WEST END REGIONAL NAVIGATION CENTER PROJECT
BID NO.: DE-26-222-SB

Addendum No. 2 Information
June 16, 2026

4.1 **Revised** "WEST END REGIONAL NAVIGATION CENTER" Plan Sheets are hereby included and shall replace the previously released "WEST END REGIONAL NAVIGATION CENTER" Plan Sheets. Changes to Plans include:

SECOND FLOOR EGRESS PLAN

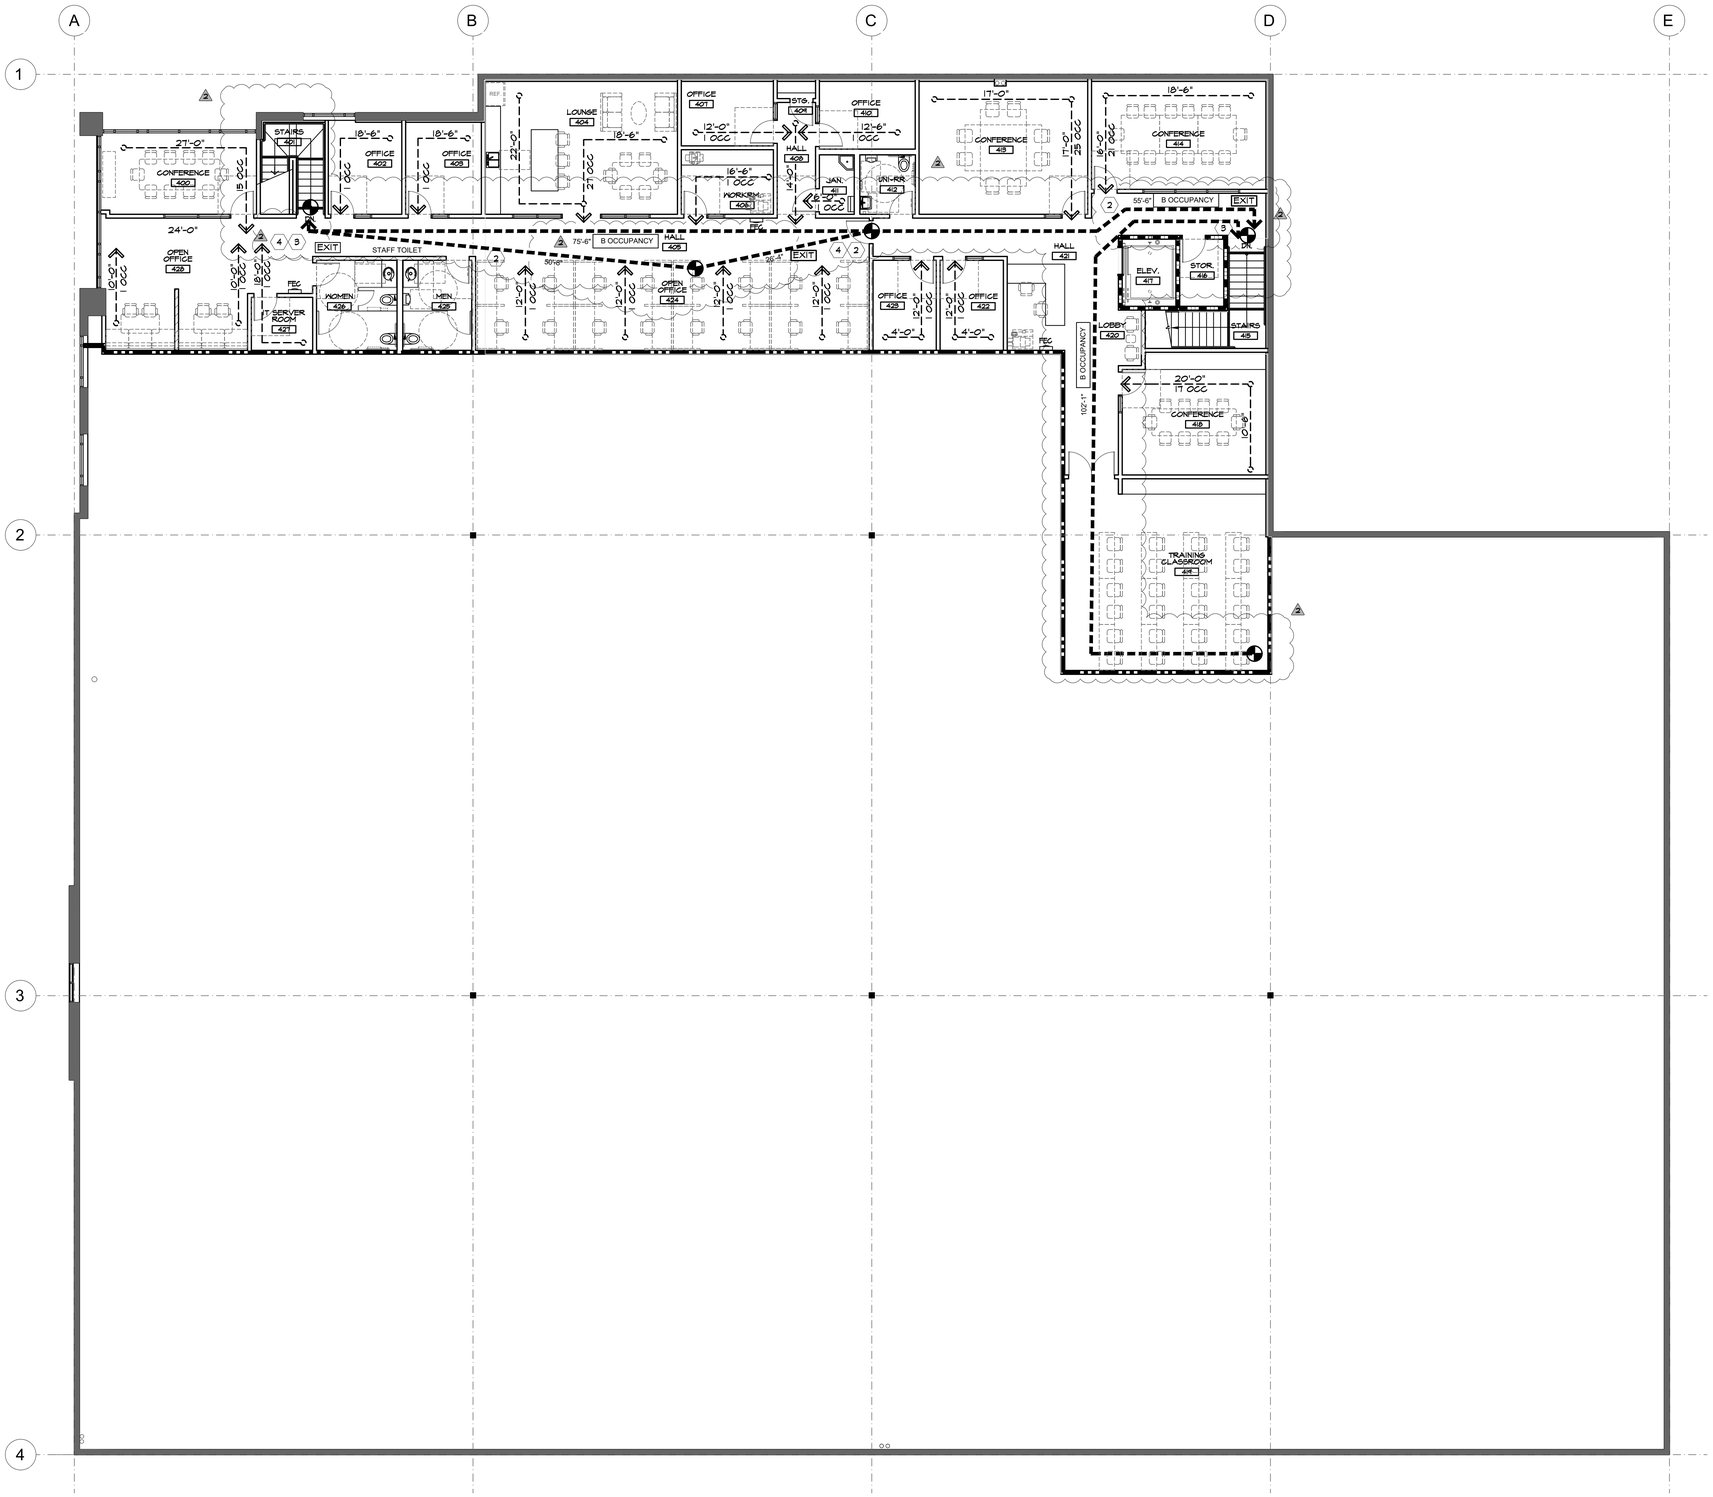
i. **Sheet EX-2:** Adjust Occupant loads Distribution and Path of Travel.
j. **Sheet OCC-1:** Reconfigure south dorm room area, adjust occupant load and egress paths. Reconfigure West Stairs. Clarify Occupant Load table.

Sheet 2 XT-1

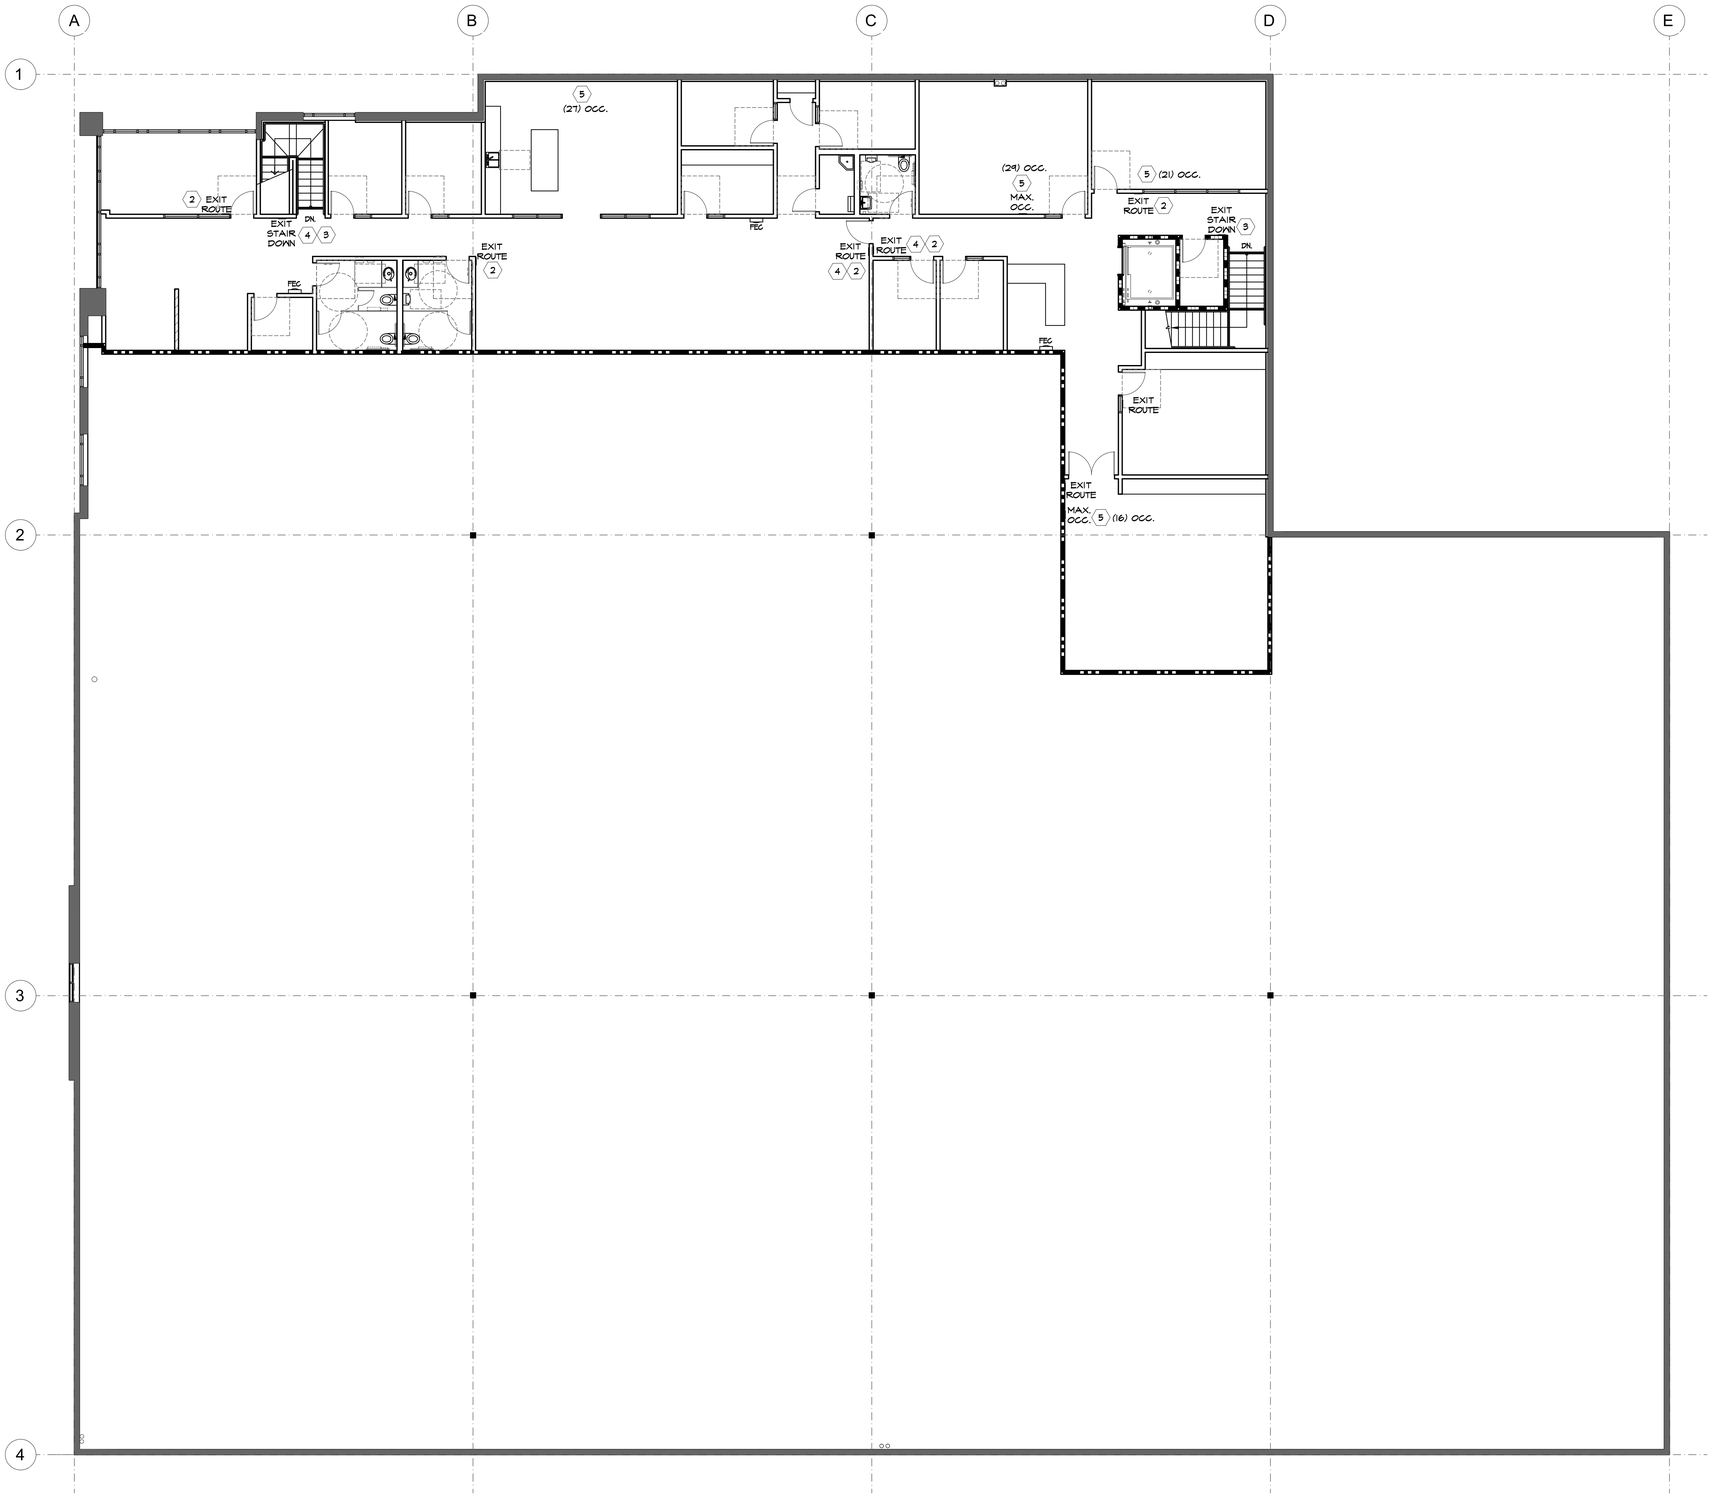
k. **Sheet OCC-2:** Reconfigure West Staff Stair. Clarify exiting travel path distance. Clarify occupant load table.
l. **Sheet XT-1:** New plan added.
m. **Sheet XT-2:** New plan added.

SP-1.3

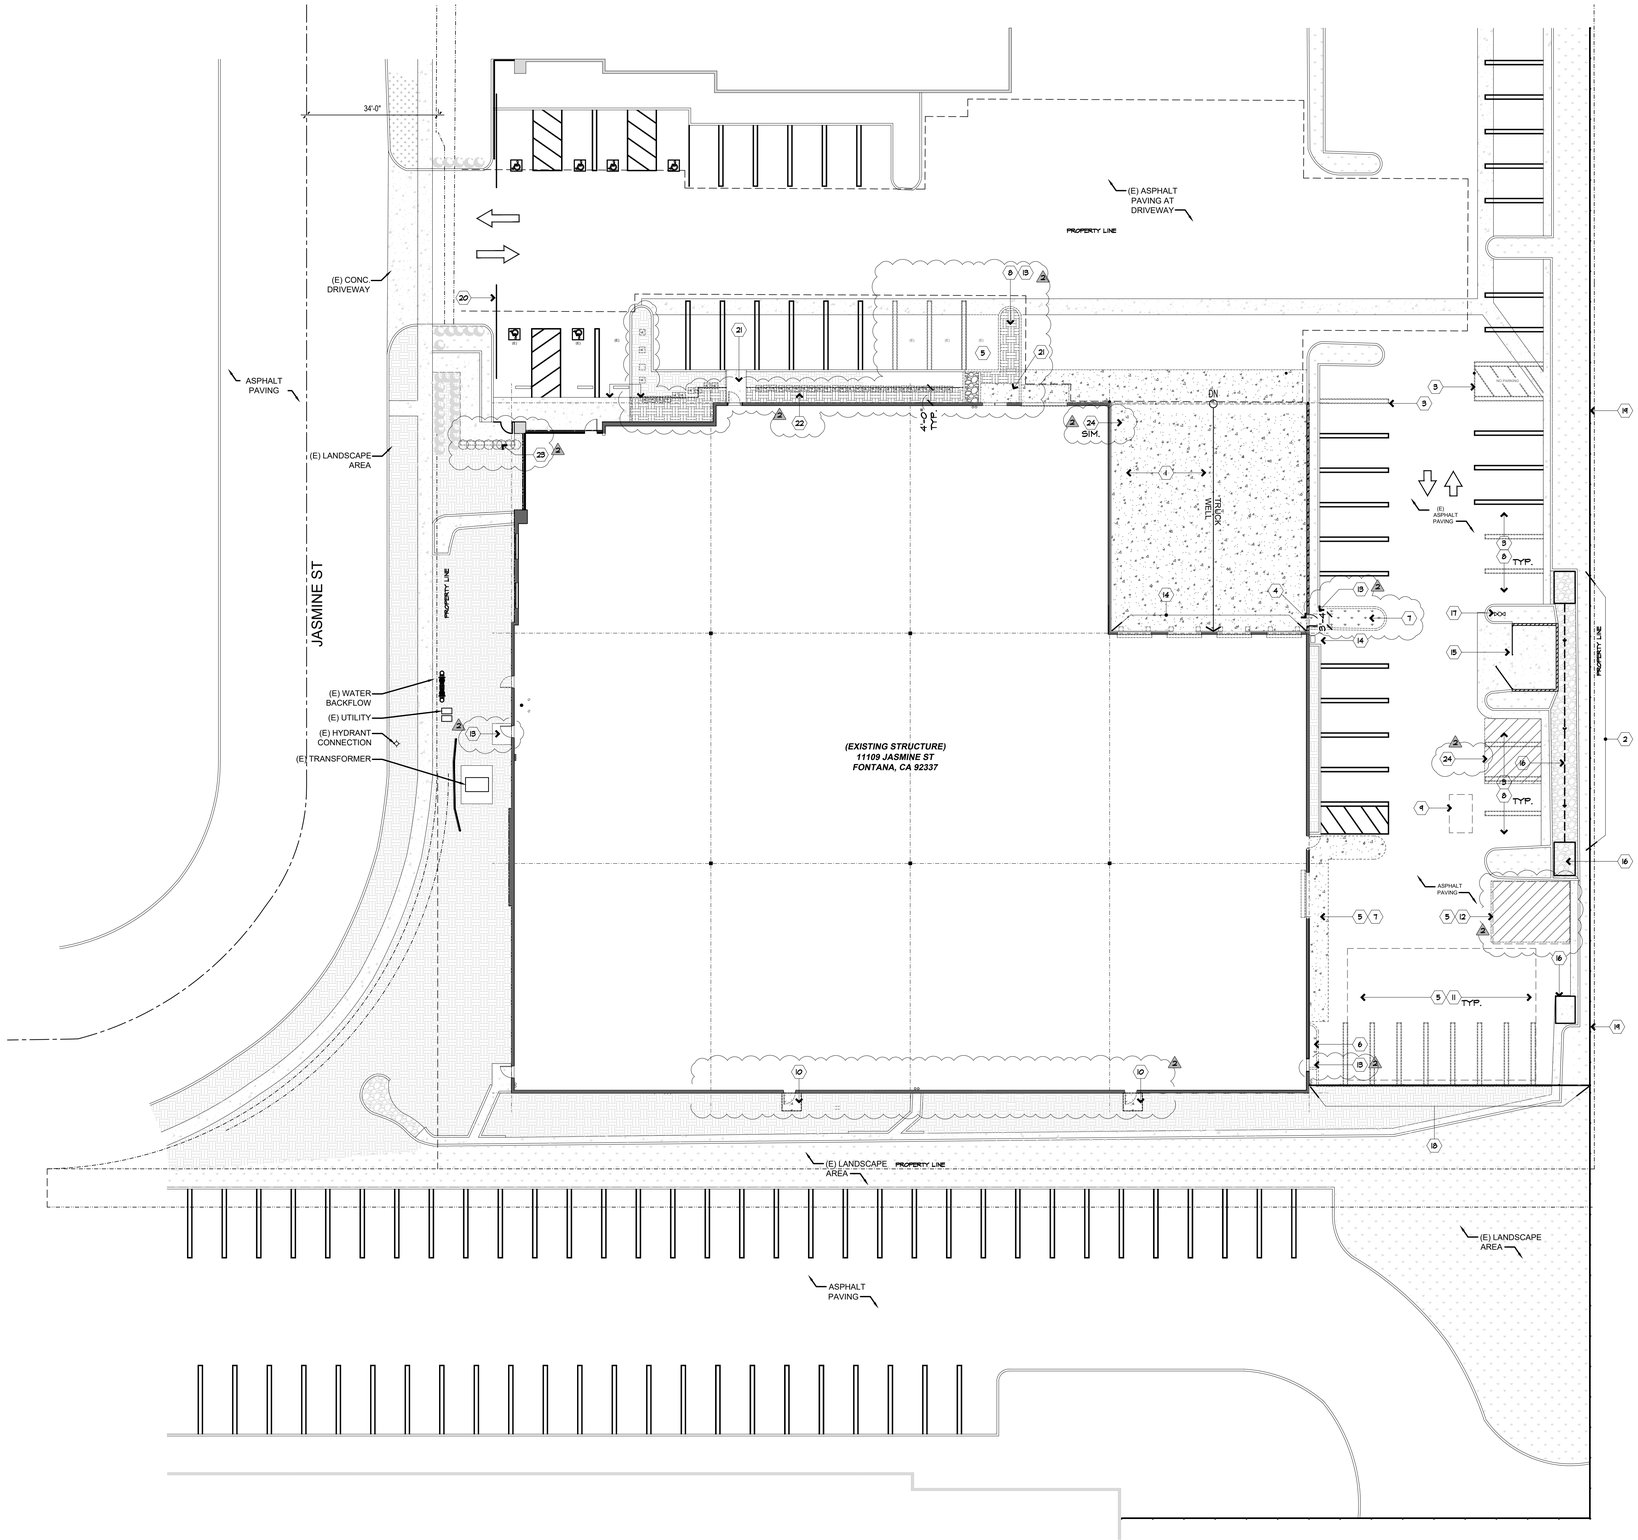
o. **Sheet SP-1.2:** Omit slide gate operator details (relocated to Details 16, 18, 21, 23 on Sheet A14.3).
p. **Sheet SP-1.3:** Add new EVCS parking stall.

A-0.2

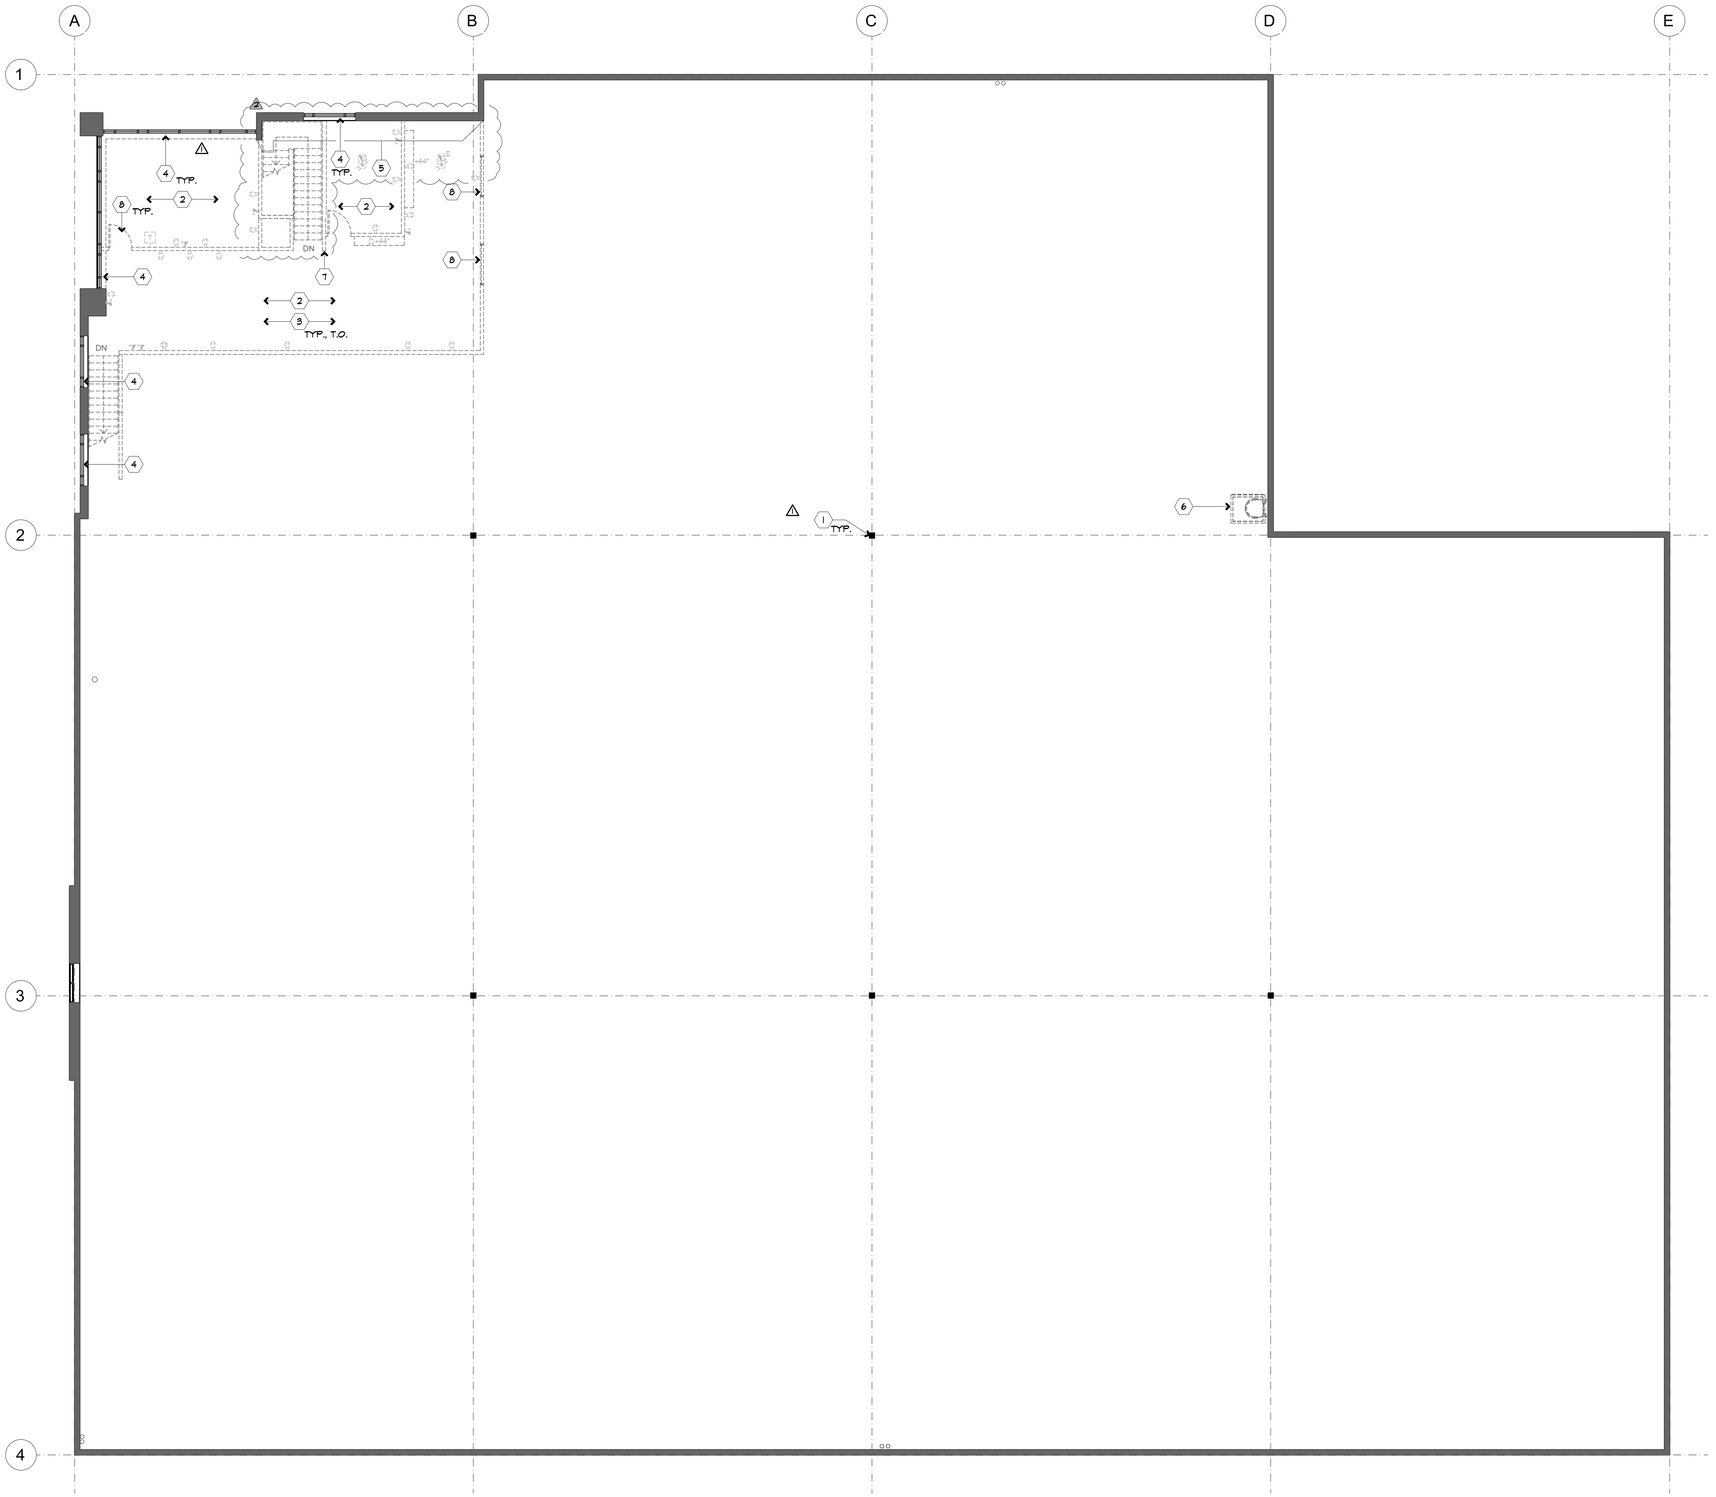
r. **Sheet A-0.2:** Clarify demolition at west stairs. Clarify demolition scope at south-side dorm room area.
s. **Sheet A-0.3:** Clarify demolition at west stairs. Clarify plan keynote No. 2. Clarify plan keynote No. 7.
